Homestead High School Expansion/Renovation Project
Phase 2B - Gymnasium and Auditorium Additions - General Construction
12.9.20
Addendum No. 2

Questions and Front End Clarifications - Pre-Bid Meeting - CSO Architects Addendum No. 2

ADDENDUM NO: 2

PROJECT: Additions & Renovations to Homestead High School
Phase 2B

CERTIFIED BY:
JAMES ROBERT LUK
No. AR00900003
STATE OF INDIANA
ARCHITECT
DRAWING NUMBER
A111-2
PROJECT NUMBER
18138

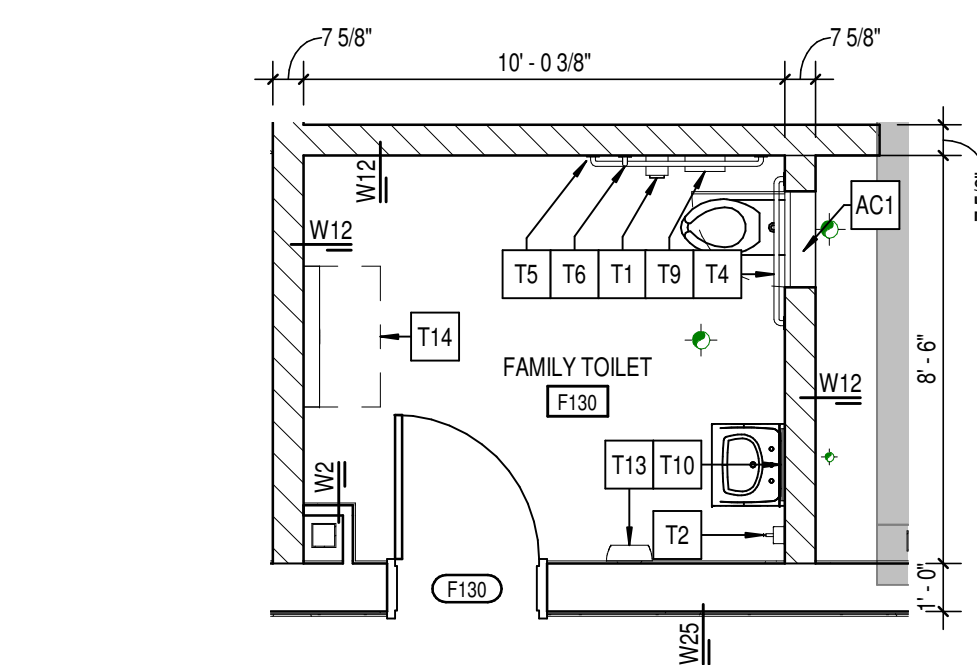
3.02 A111-2 – ROOF PLAN PHASE 2 – A, B, C, G, L, N

A. Add Roof Plan Note 14. Reissued sheet.

CEILING MOUNTED
TOILET PARTITION
SUPPORT
SCALE: 3/4" = 1'-0"

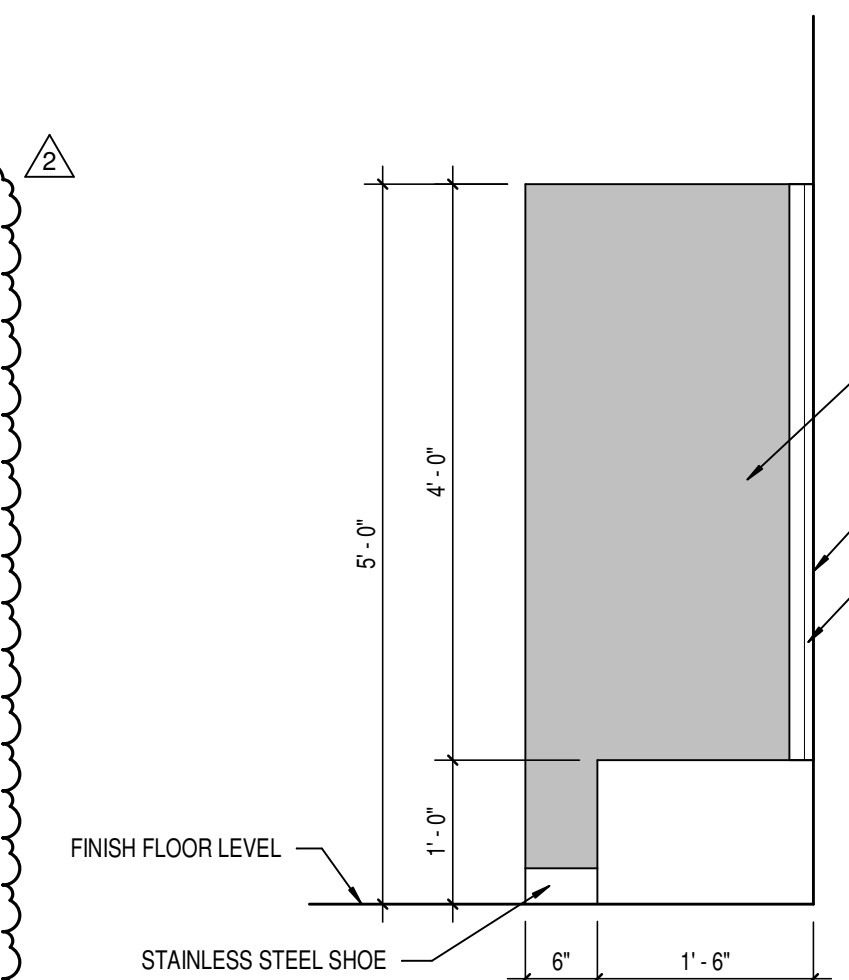
3.011 A701-2 – ENLARGED RESTROOM PLANS

- A. Add **CEILING MOUNTED TOILET PARTITION SUPPORT** detail as shown on the attached sheet.

DRAWING NUMBER
A756-2

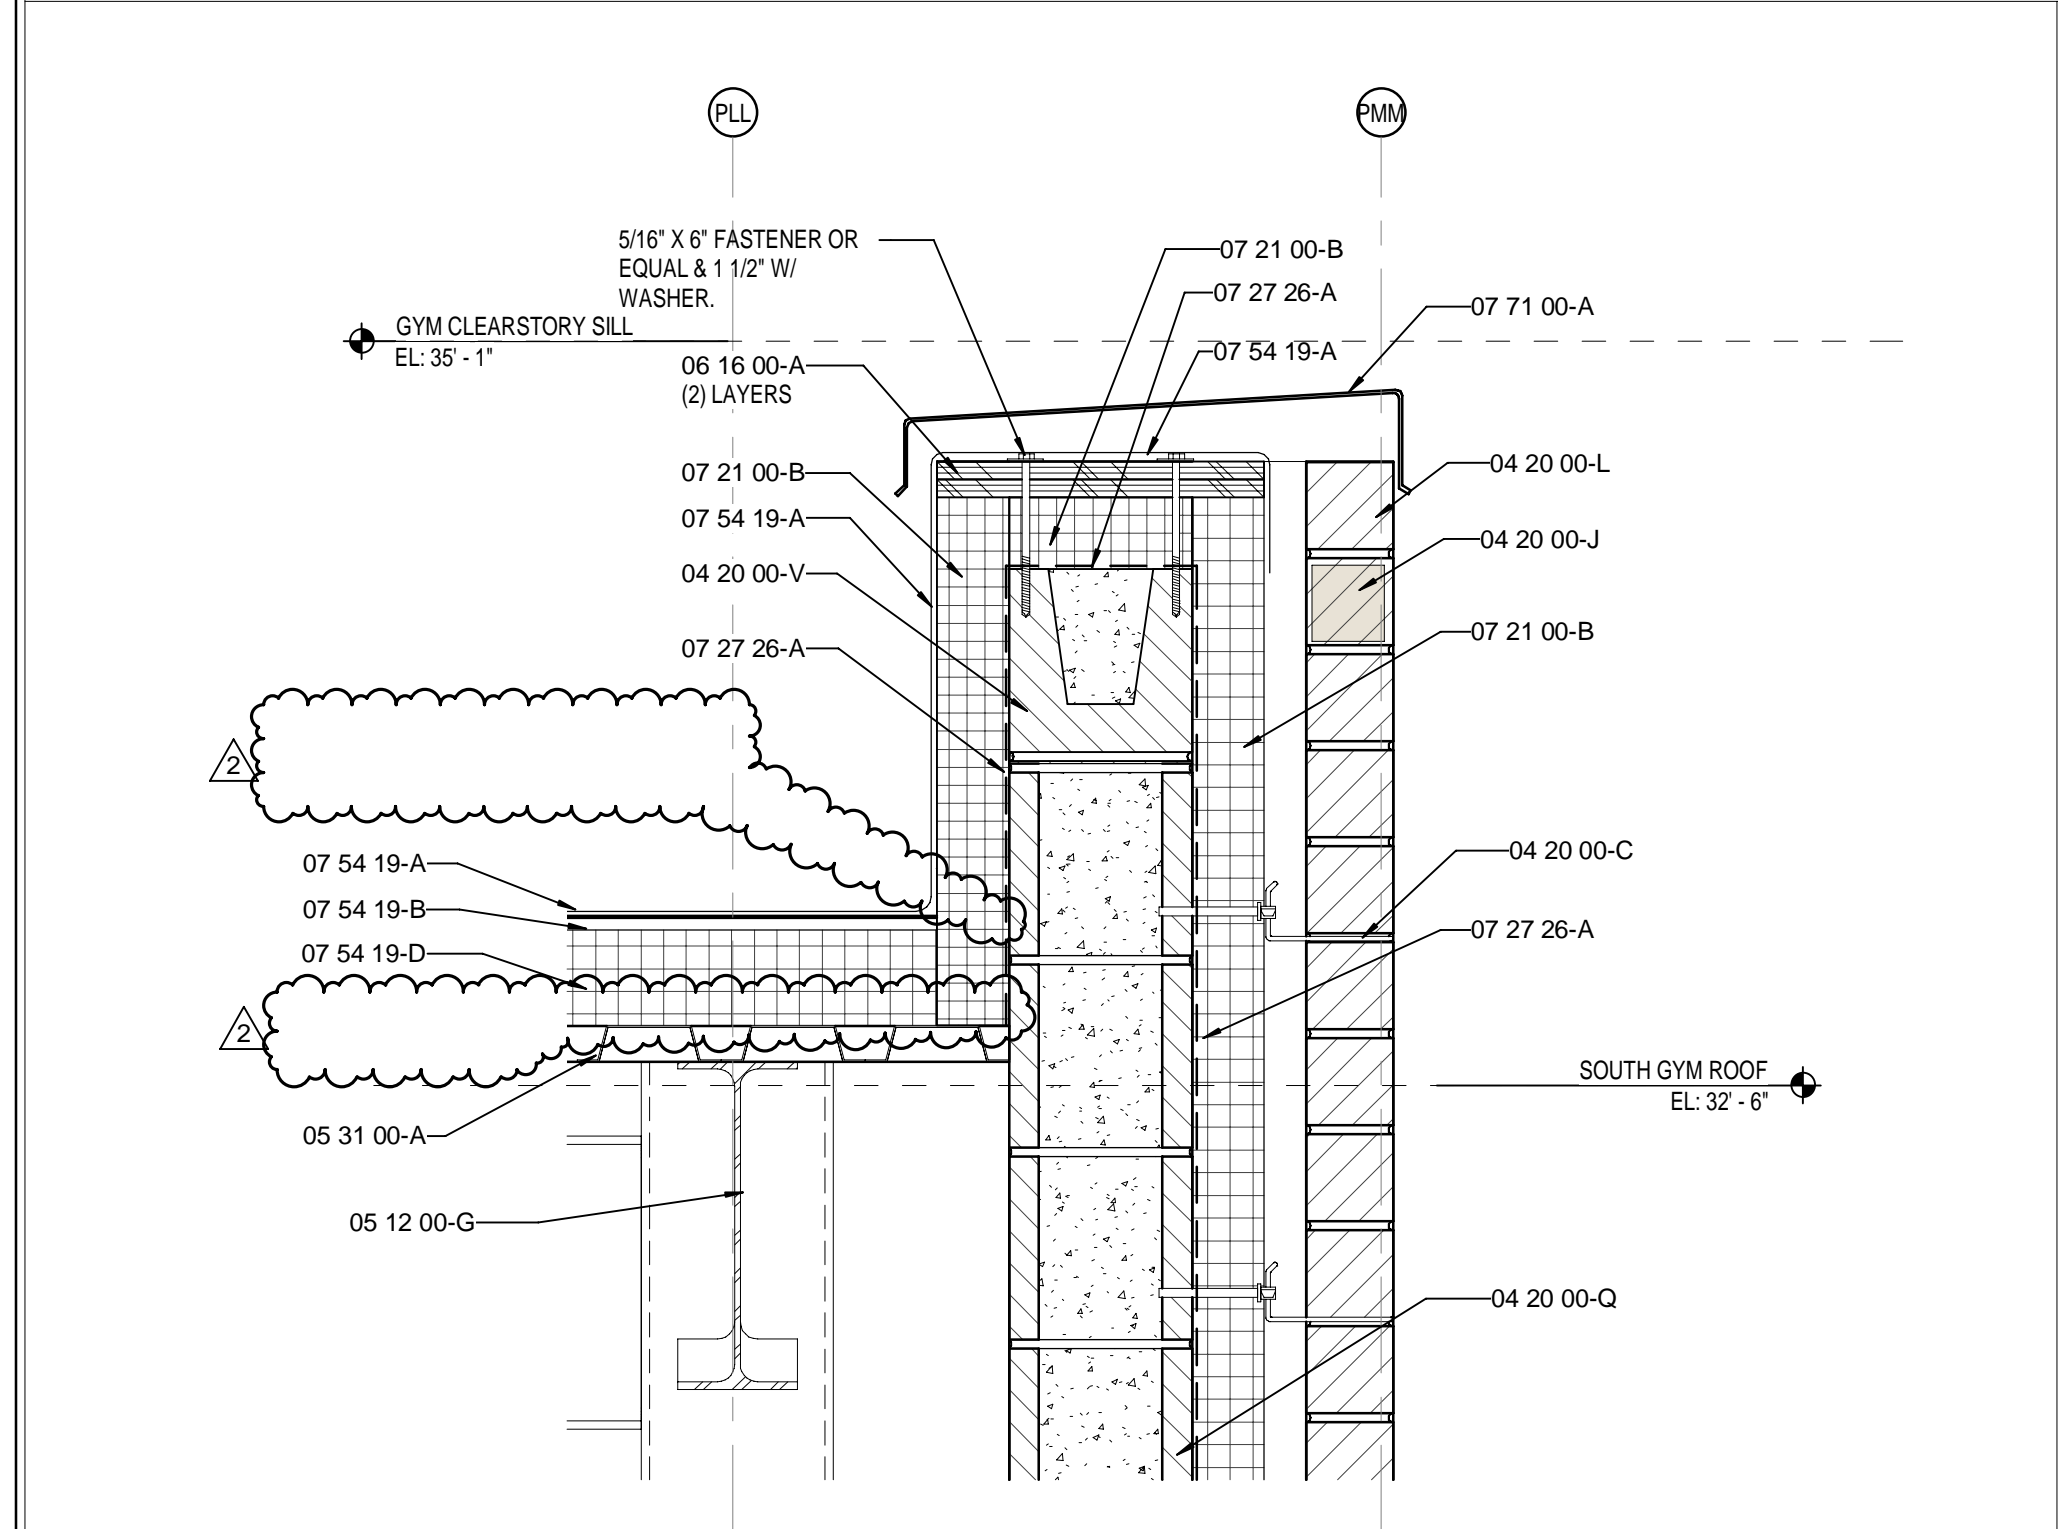
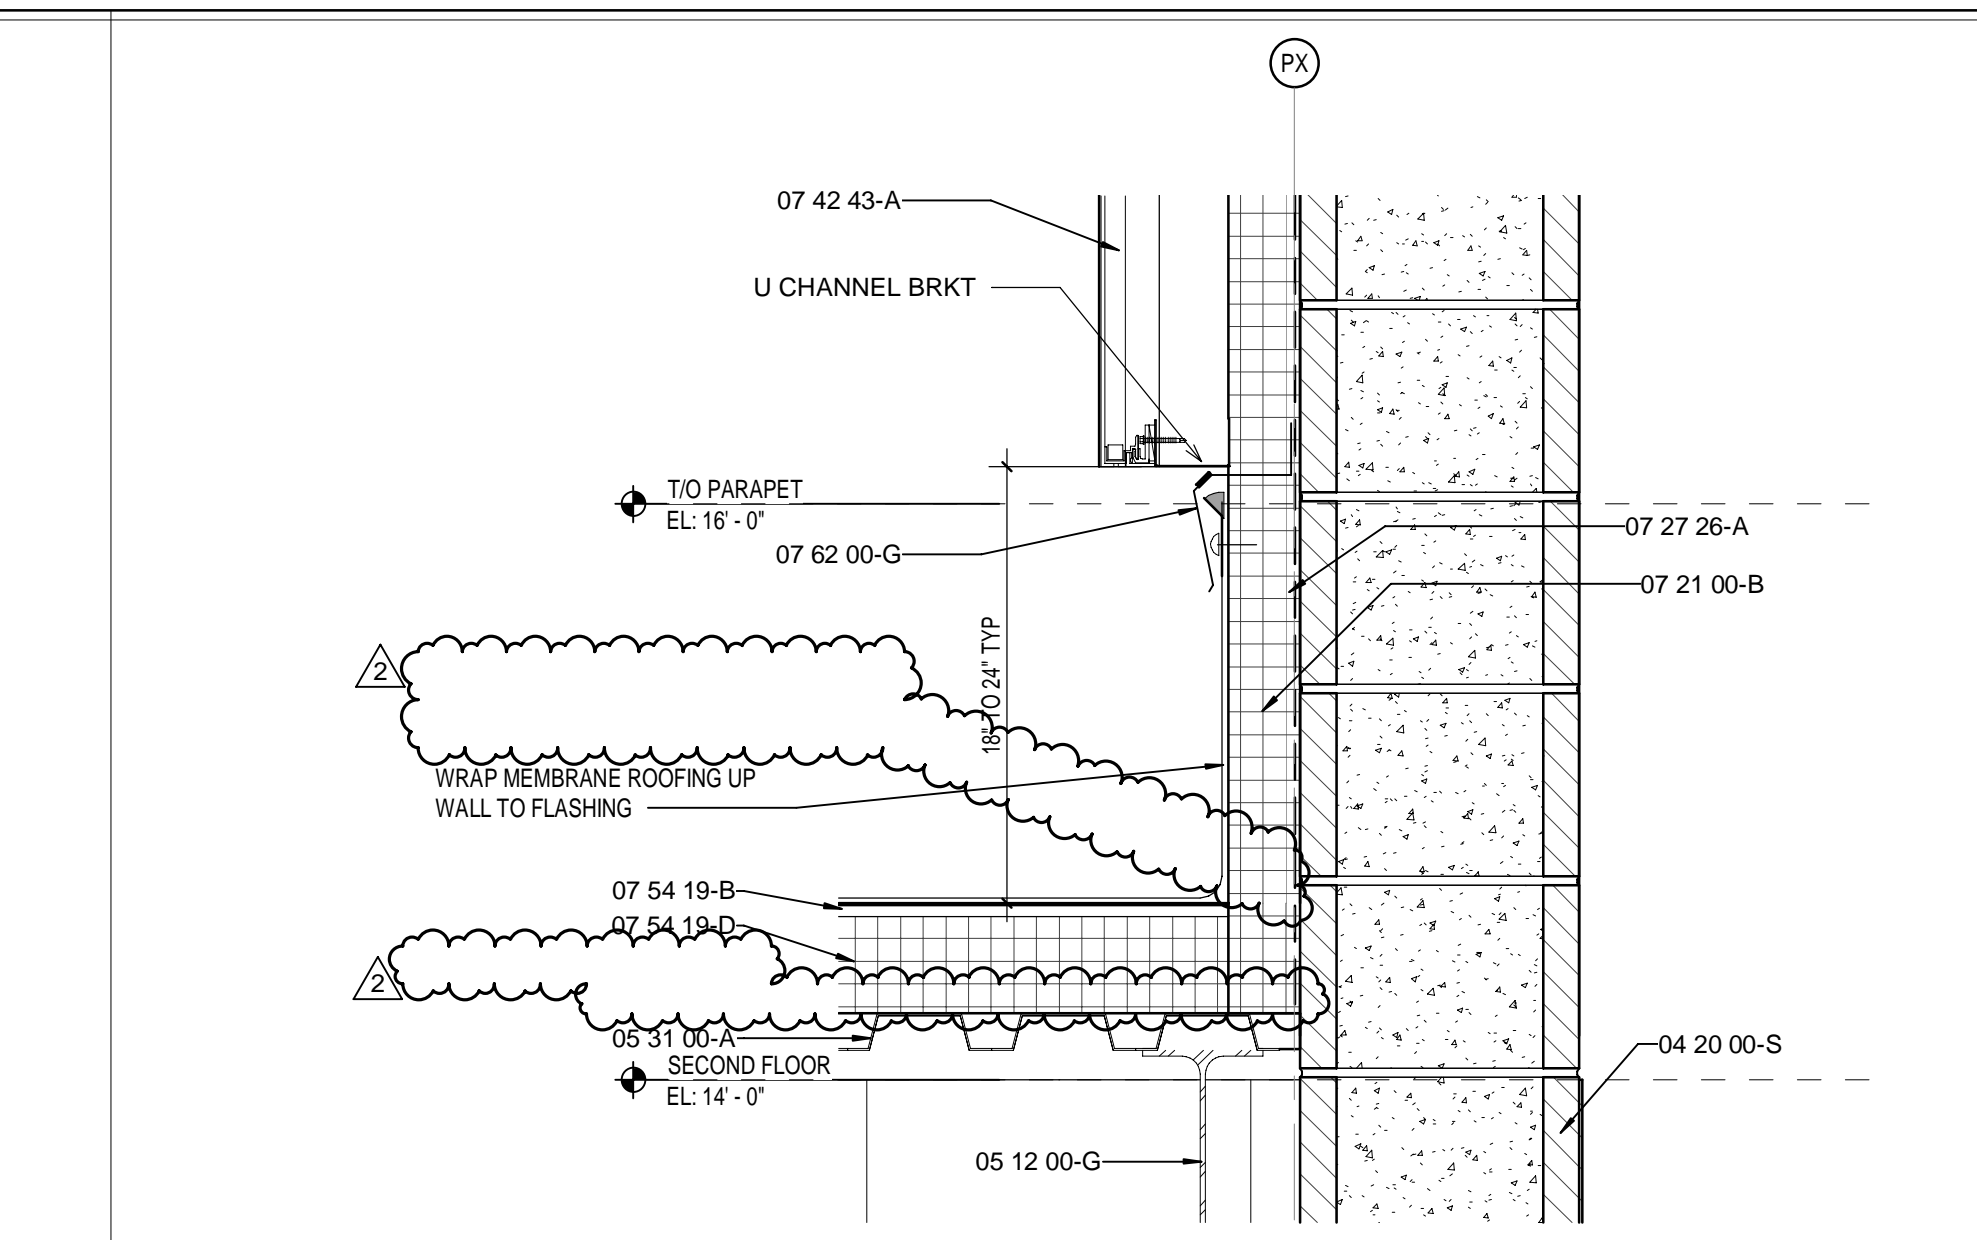
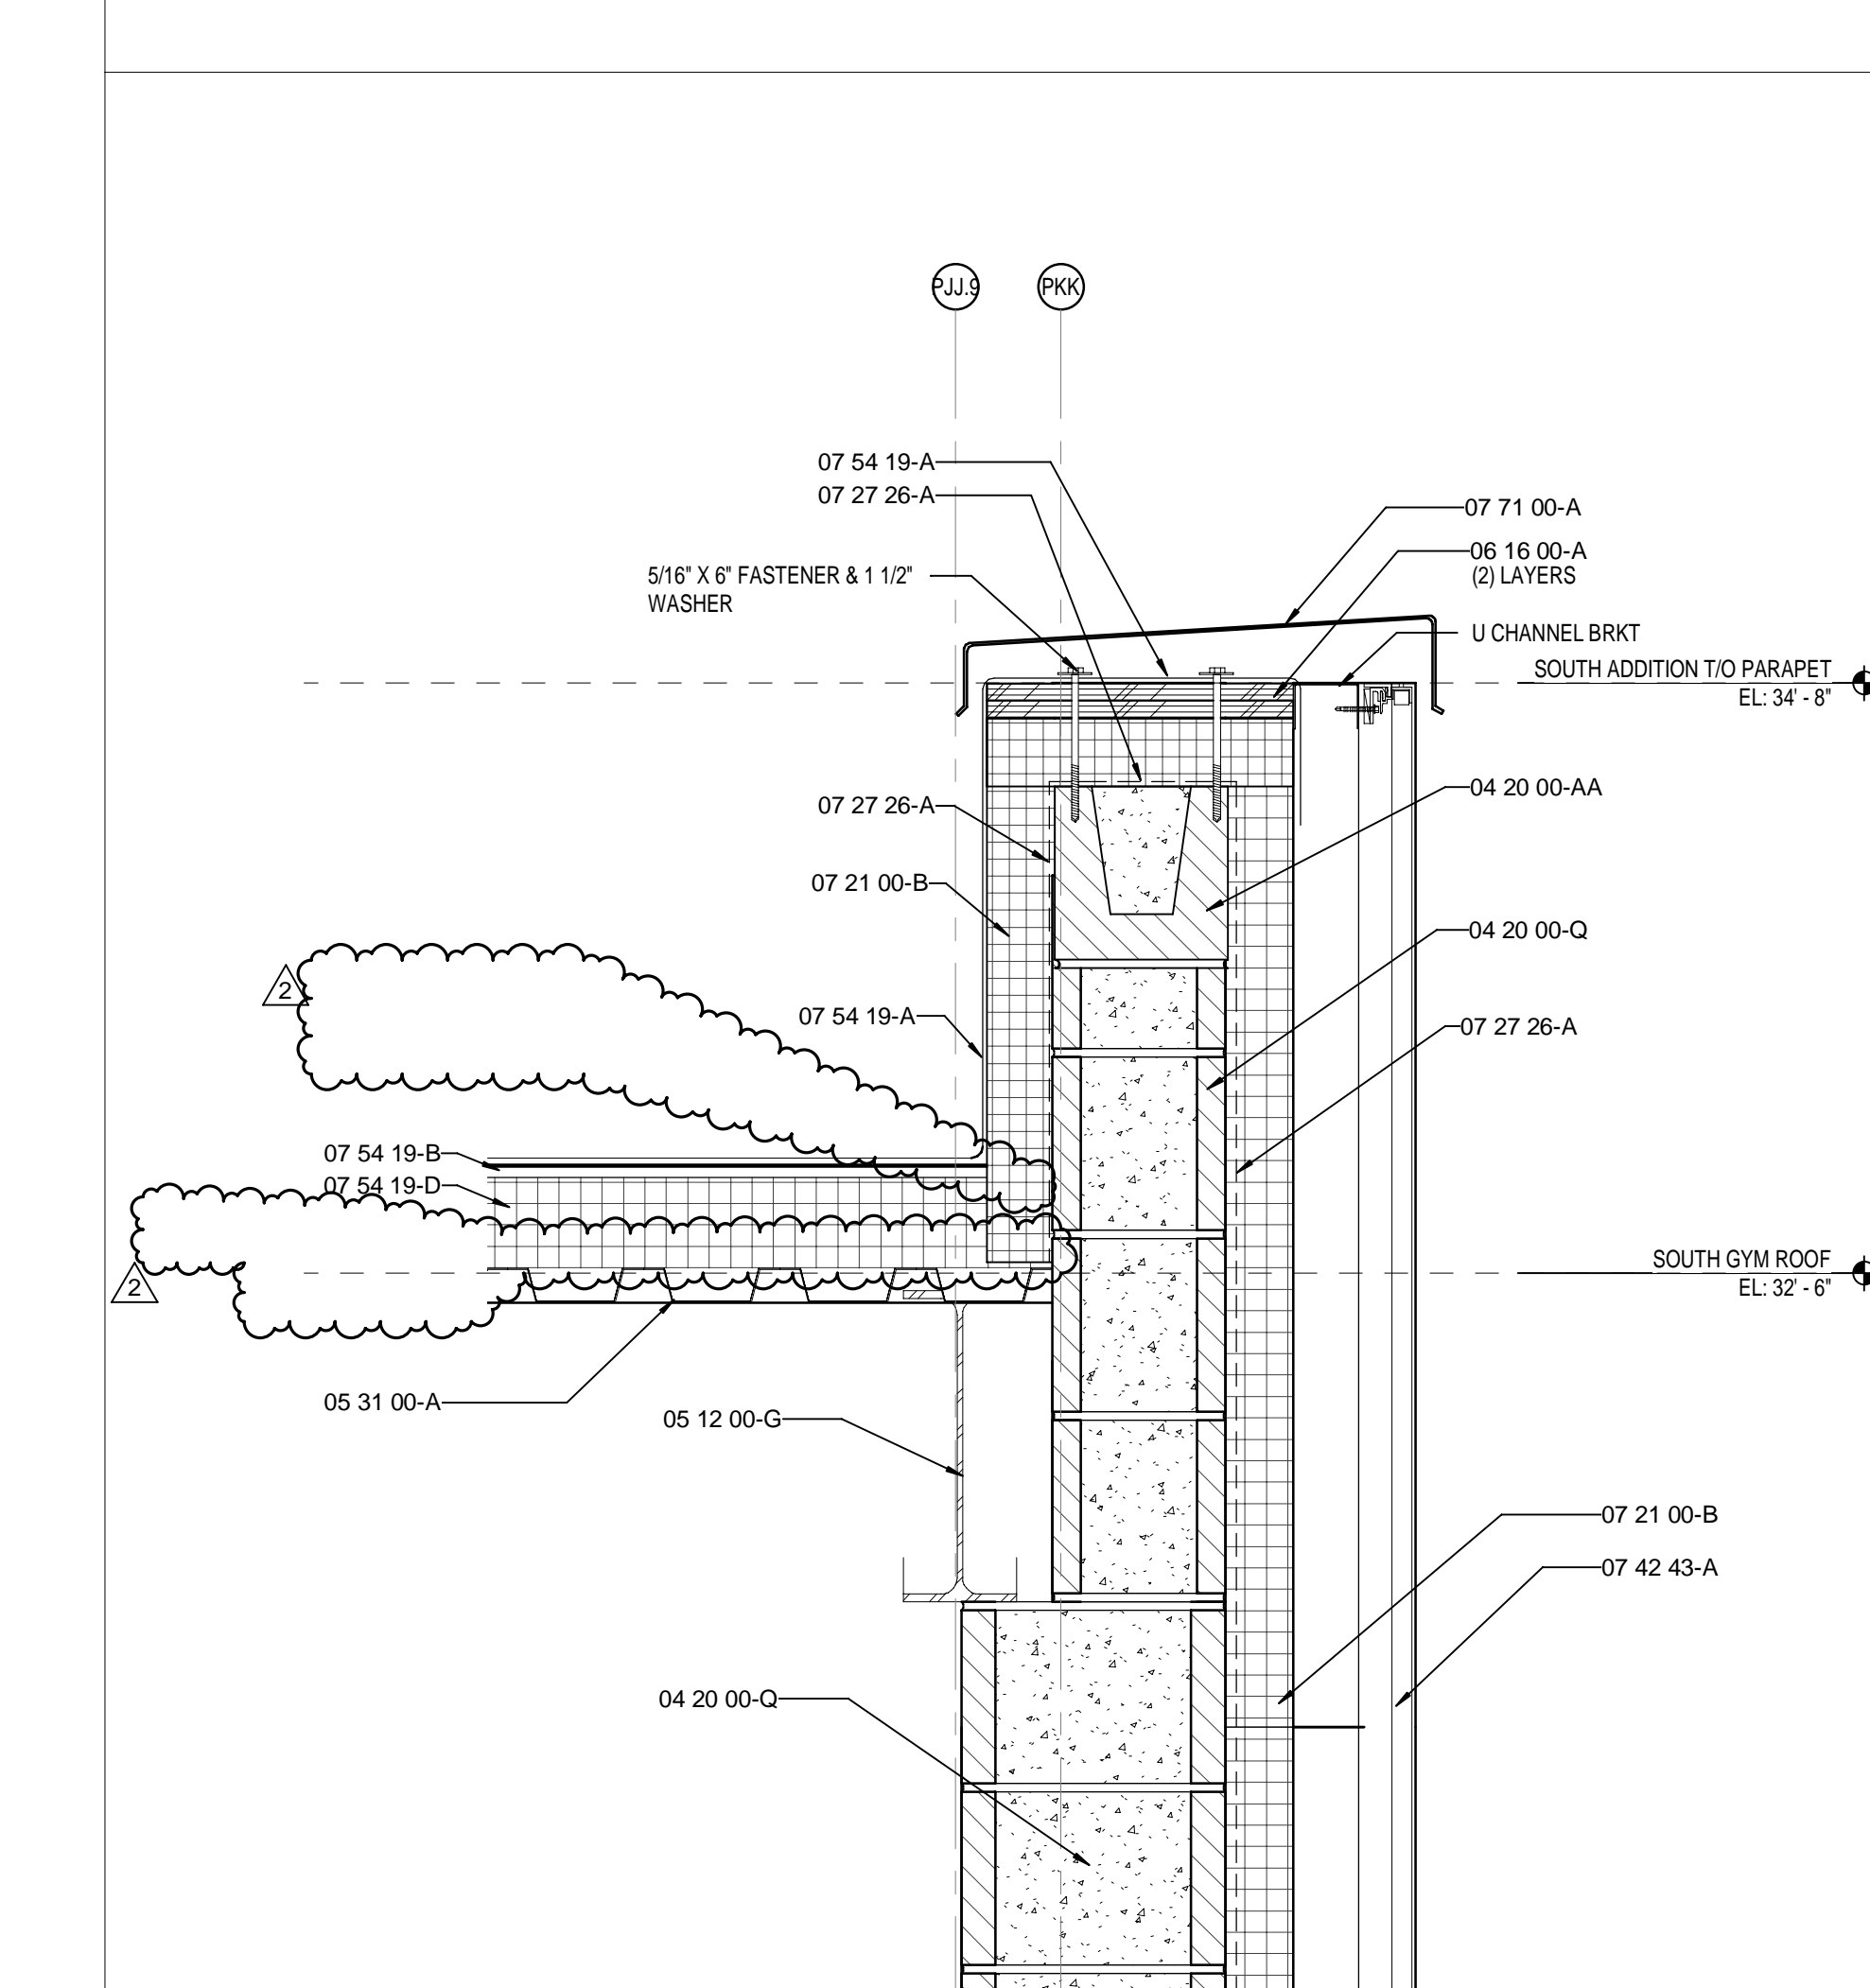
3.012 A756-2 – ENLARGED PLAN DETAILS

- A. Delete roof vapor barrier membrane and ½" gypsum deck board 07 54 19-B at all areas with corrugated metal deck. Note: The only area to receive a roof vapor barrier is at the concrete roof deck at the auditorium.
